Engineering Change Notice

The following table contains a list of engineering changes that are not reflected in the Tsi381 Evaluation Board Schematics.

Tsi381 Evaluation Board Schematic

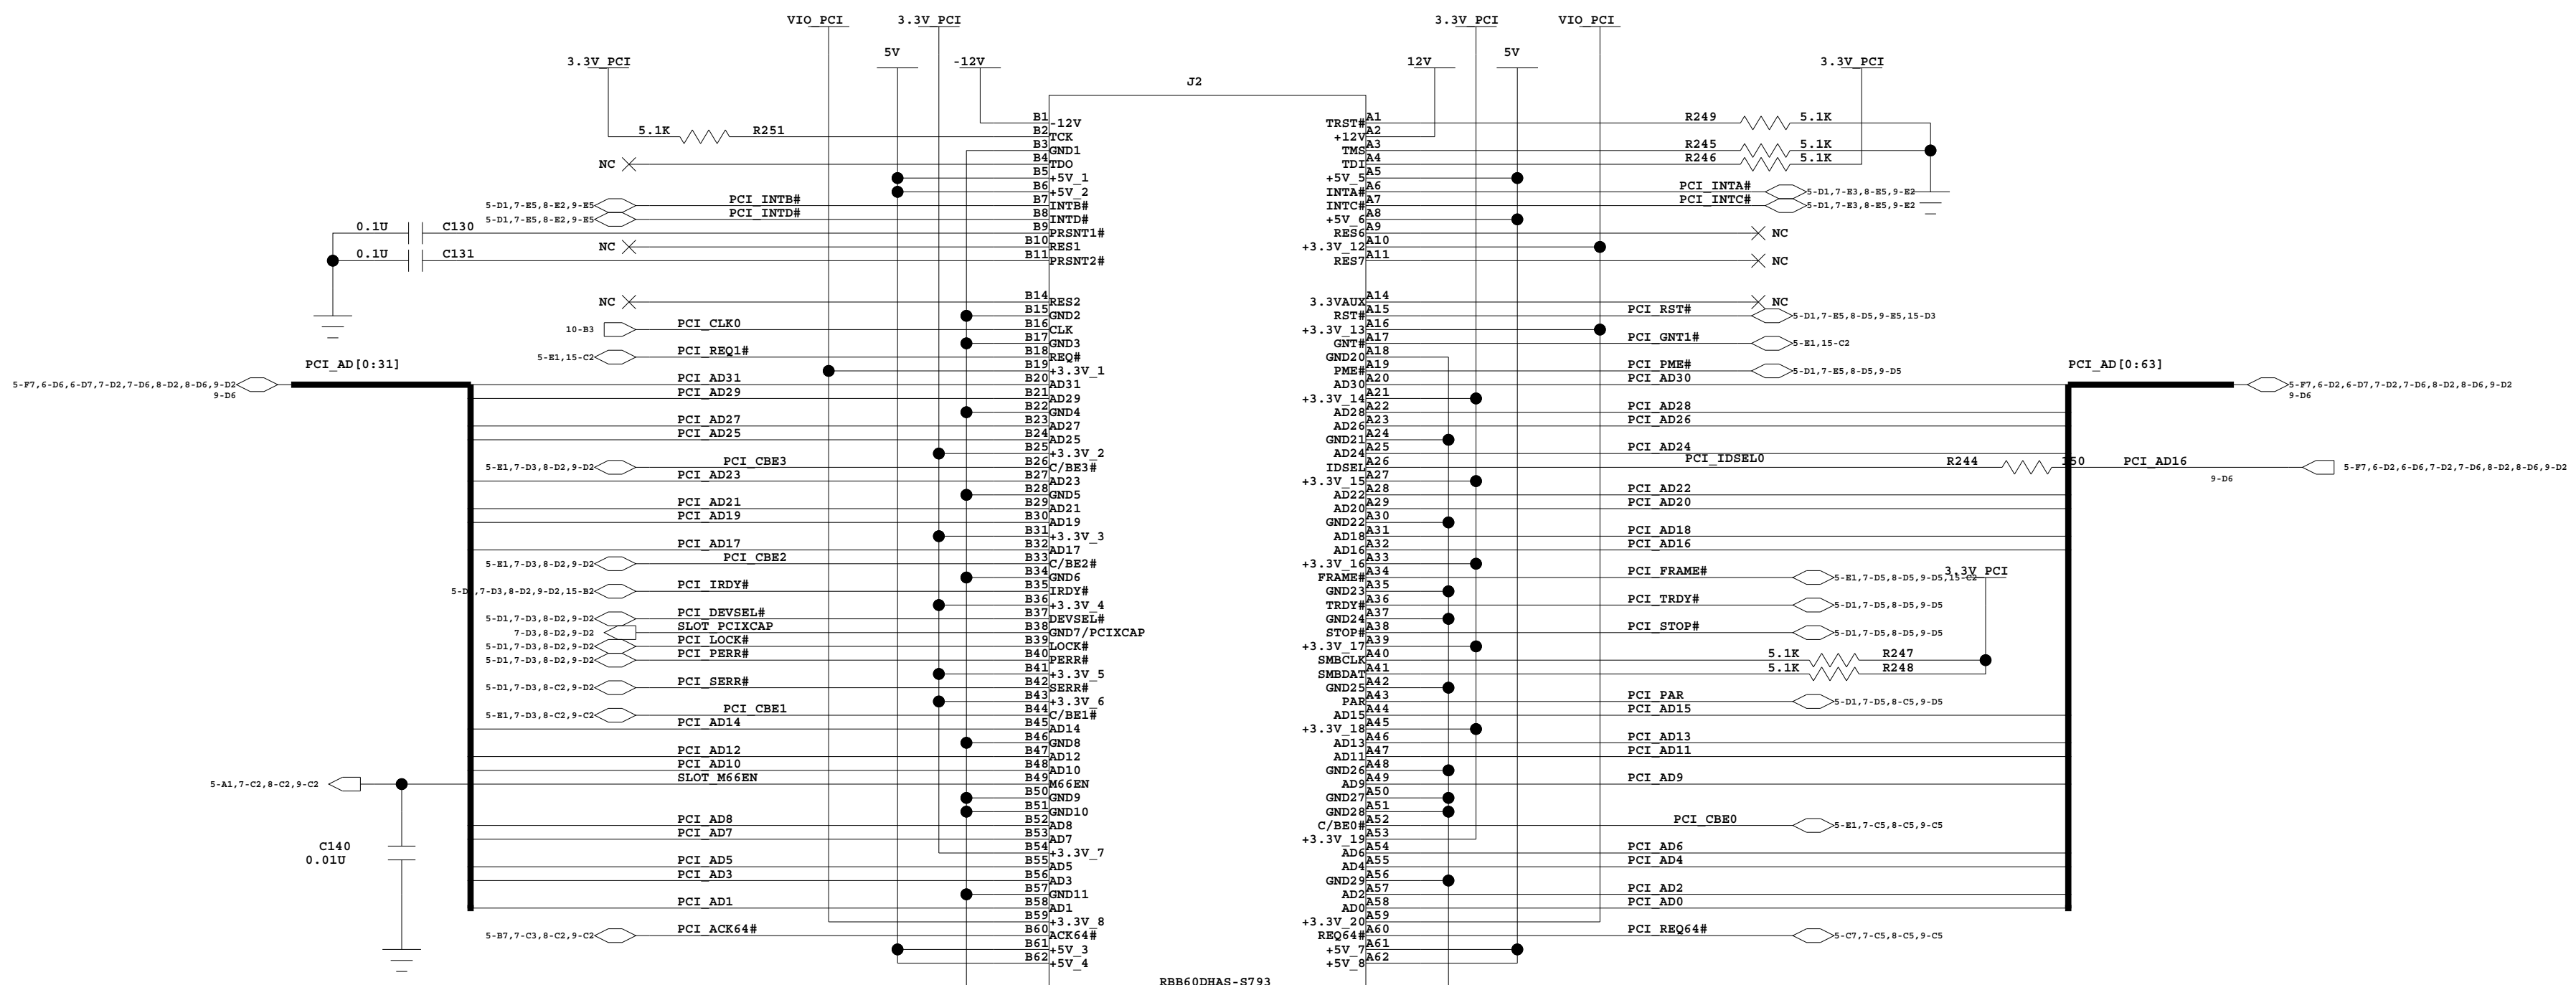
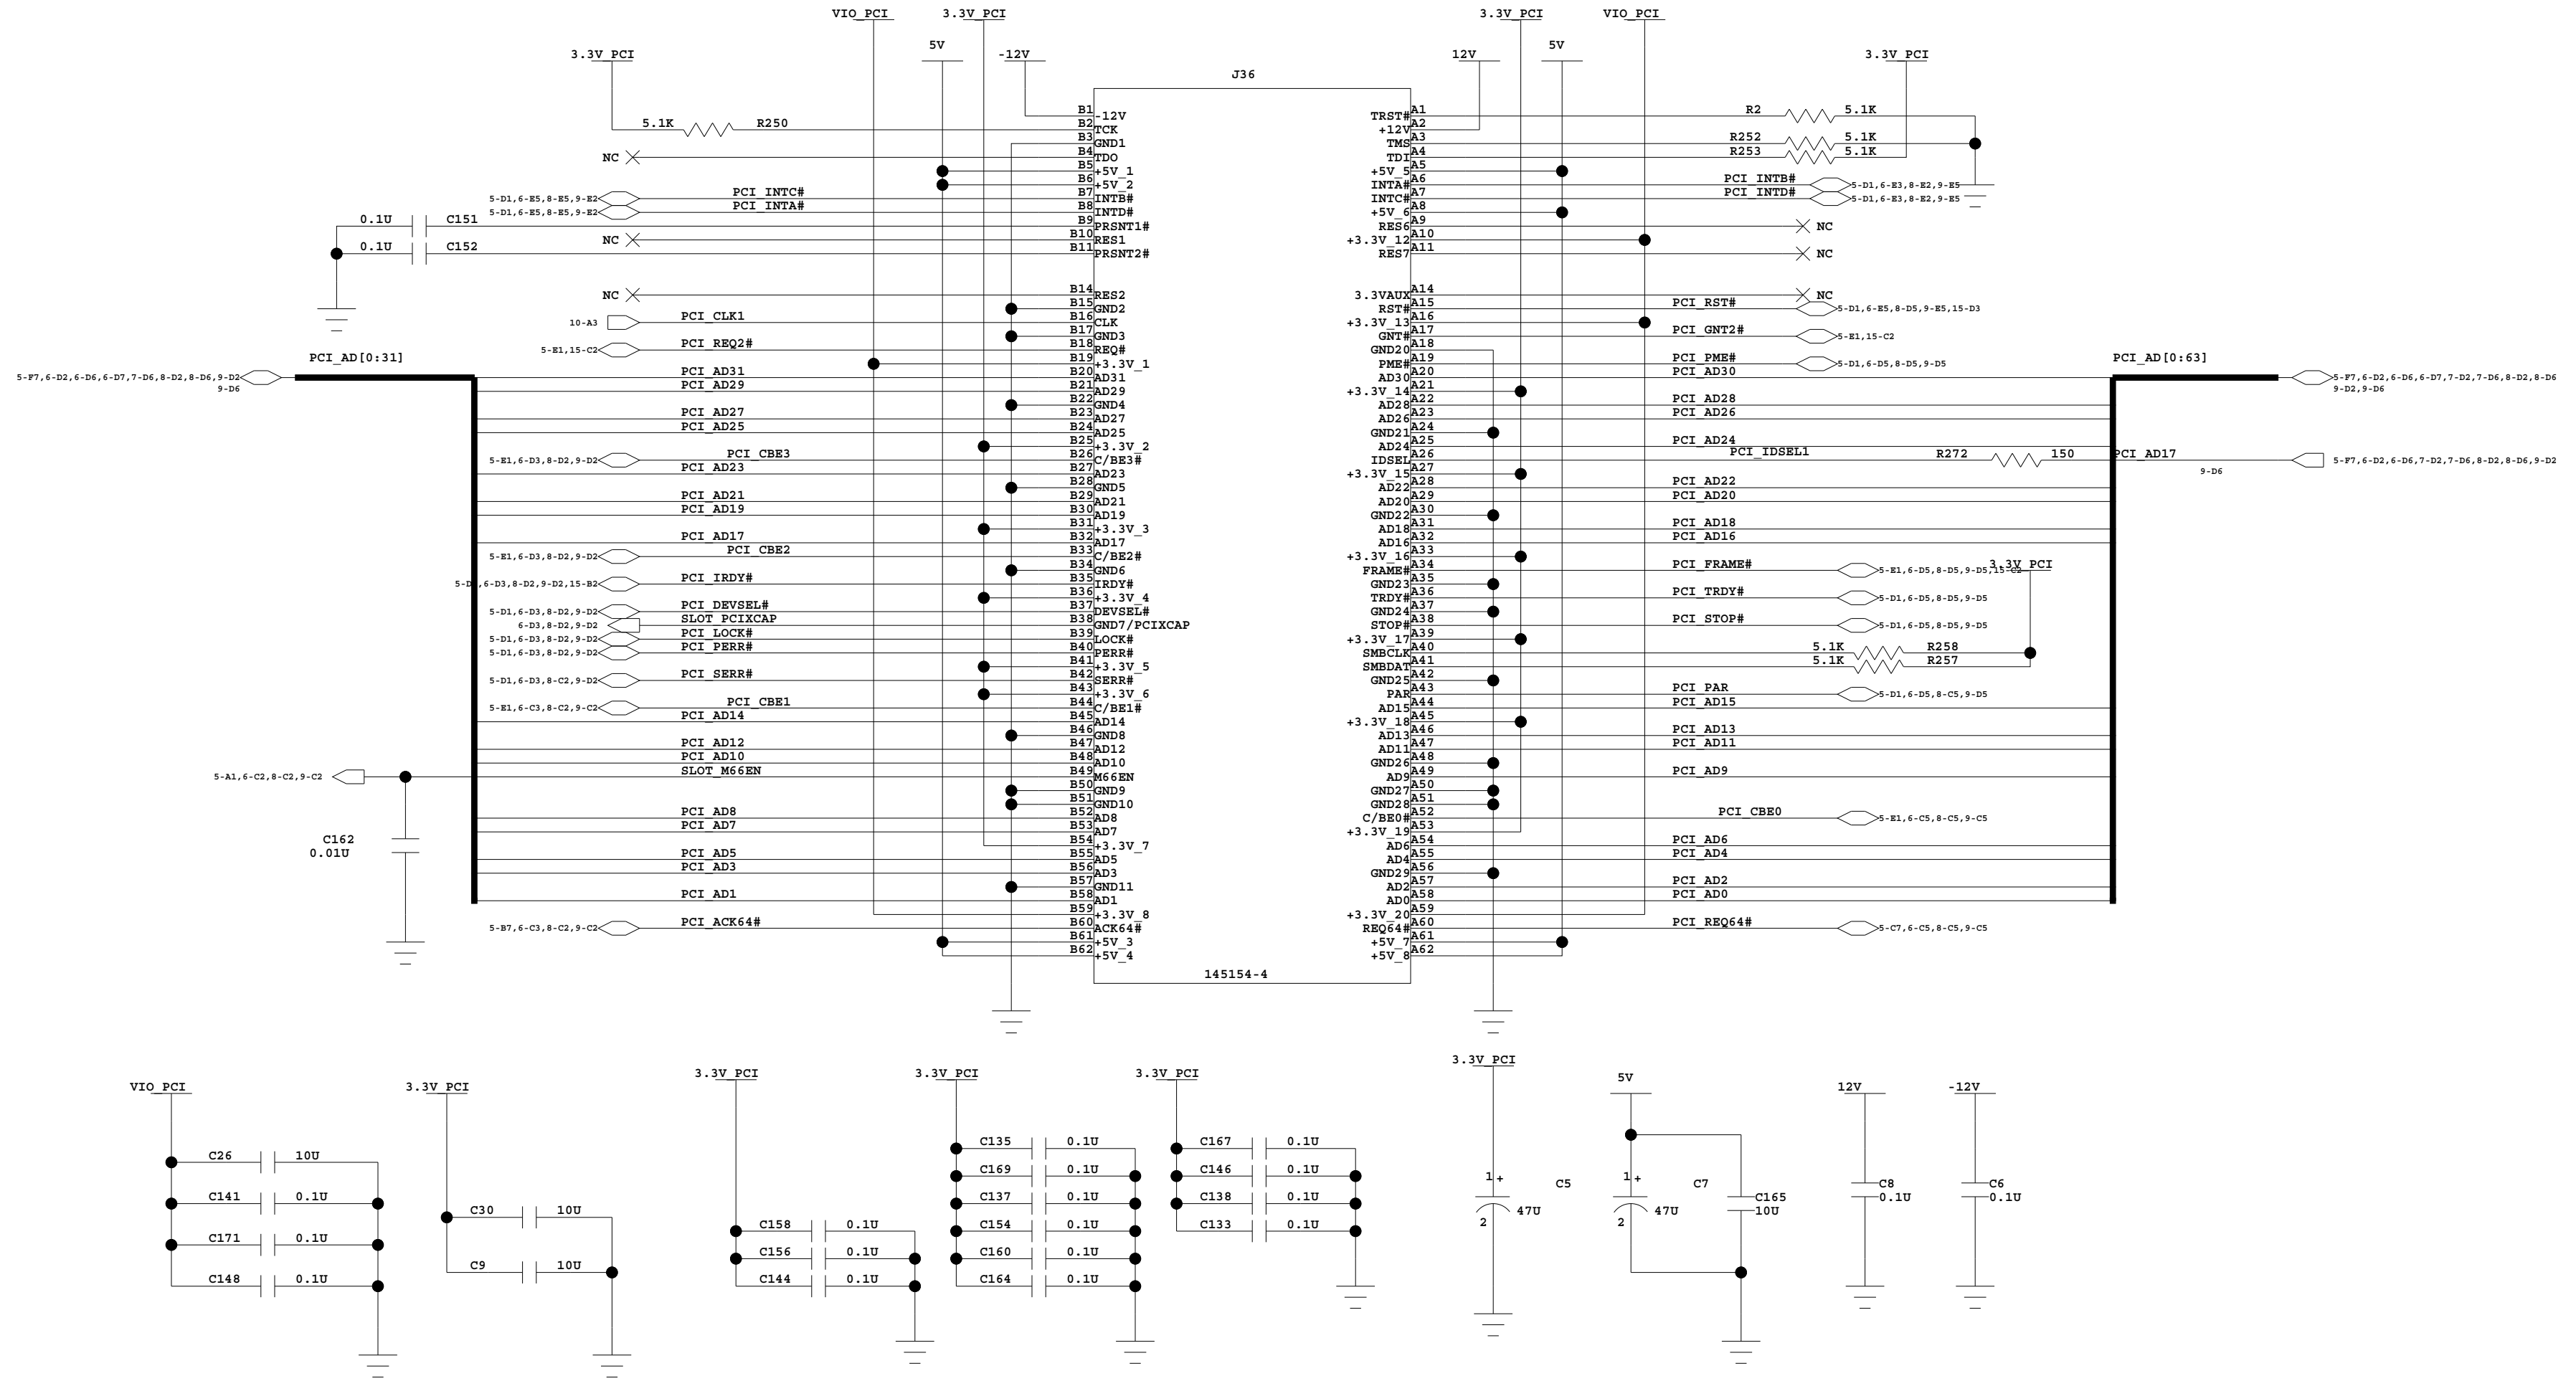
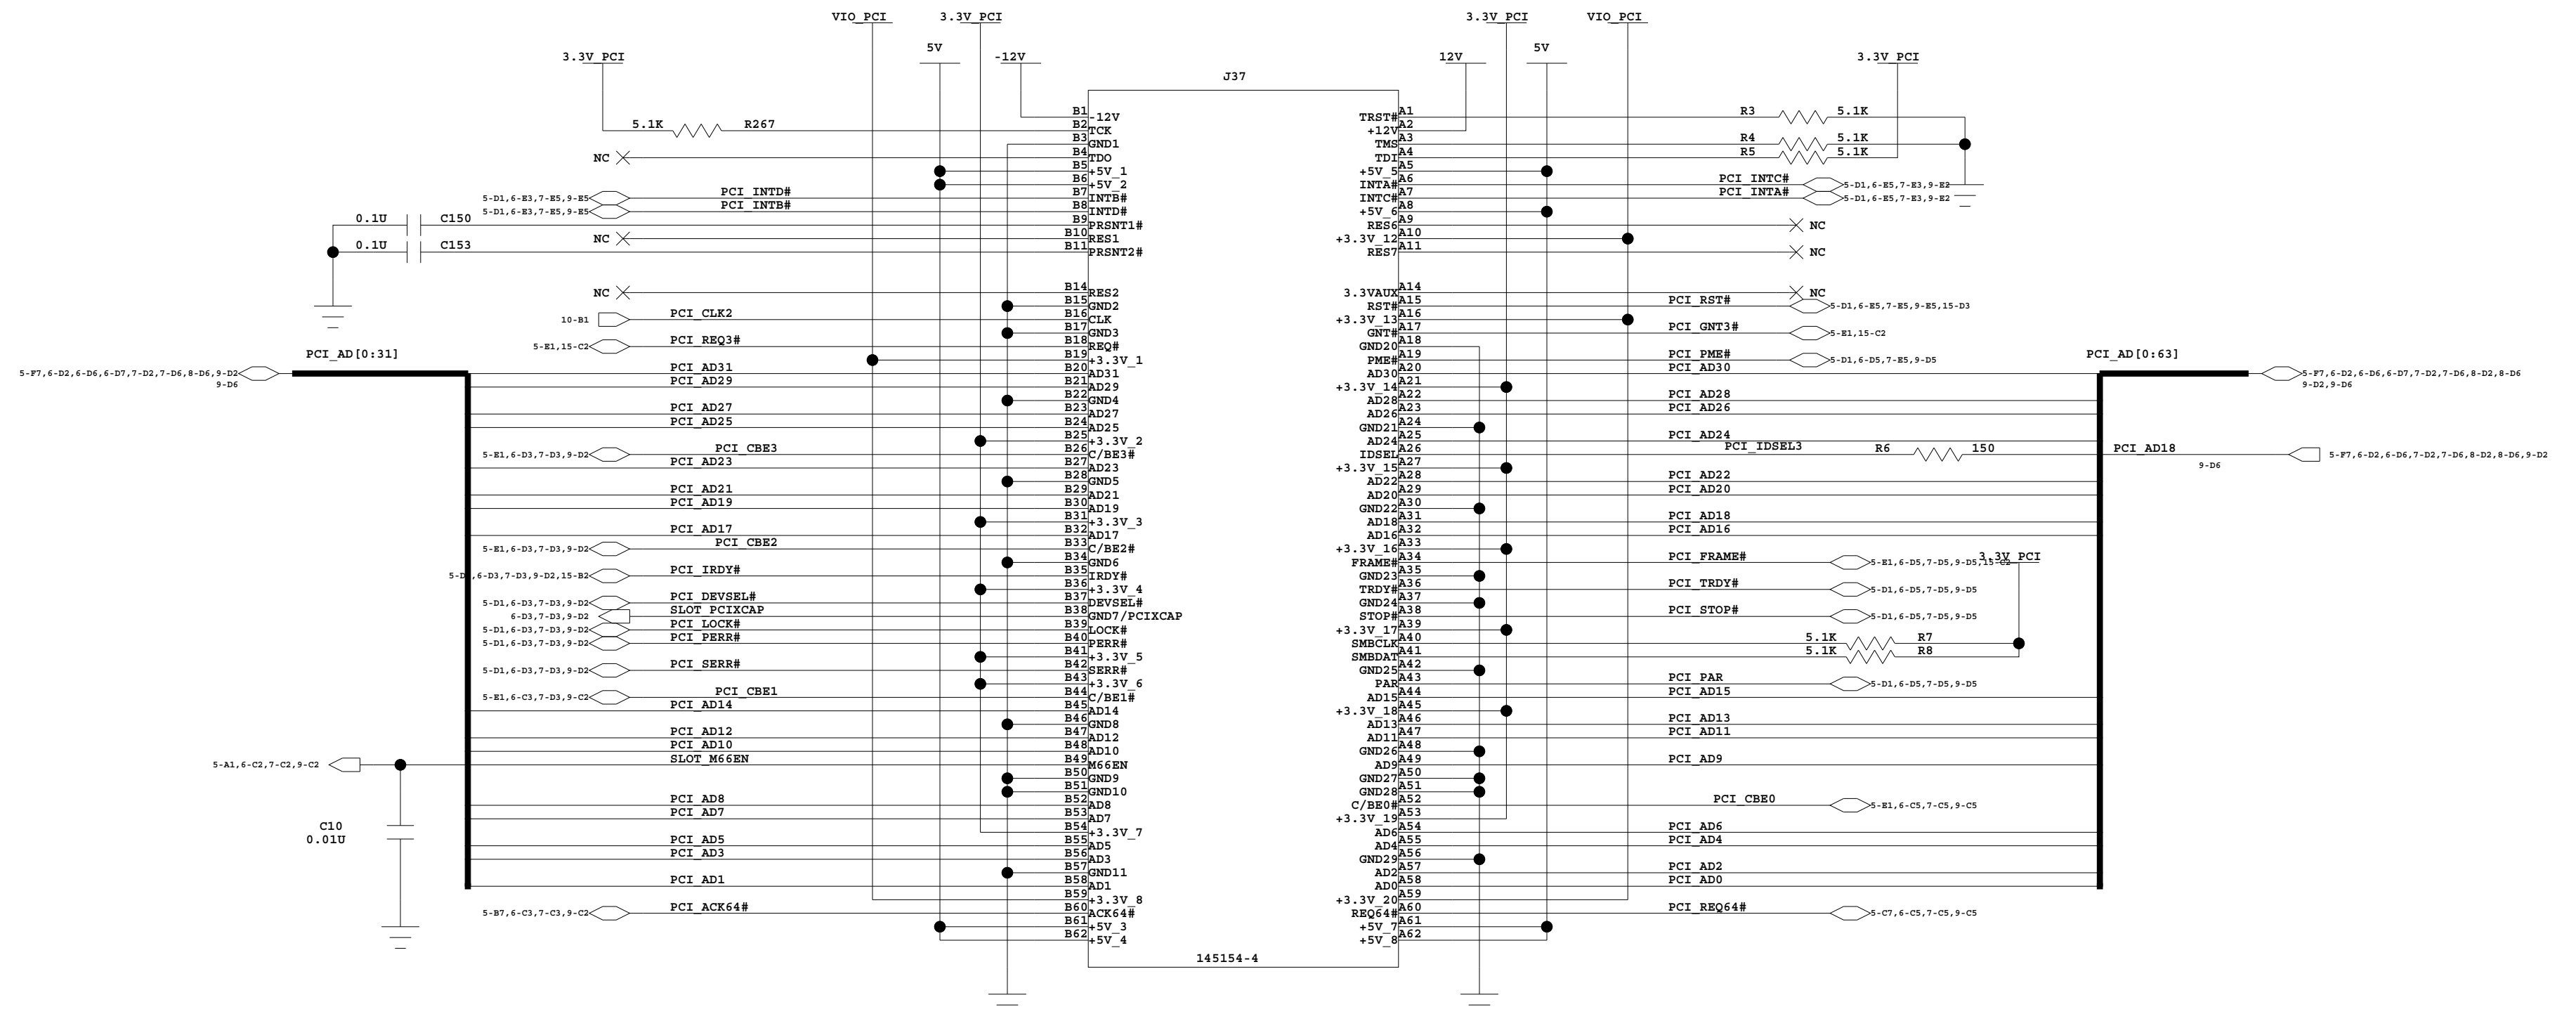
No.	Item(s)	Original	Change To
1	Tsi381 Device	Tsi381-66ILZ1	Tsi381-66ILZ2
2	3.3Vaux on J1, J2, J36, J37 ^a	No connection	Short pin A14 (3.3Vaux) to pin A16 (VIO_PCI) with 0-Ohm (0603) resistor

a. 3.3Vaux does not provide power to plug-in cards when the system is powered down.

No.	Item(s)	Original	Change To
1	Tsi381 Device	Tsi381-66ILZ1	Tsi381-66ILZ2 ^a
2	3.3Vaux on J1, J2, J36, J37 ^b	No connection	Short pin A14 (3.3Vaux) to pin A16 (VIO_PCI) with 0-Ohm (0603) resistor

b. 3.3Vaux does not provide power to plug-in cards when the system is powered down.
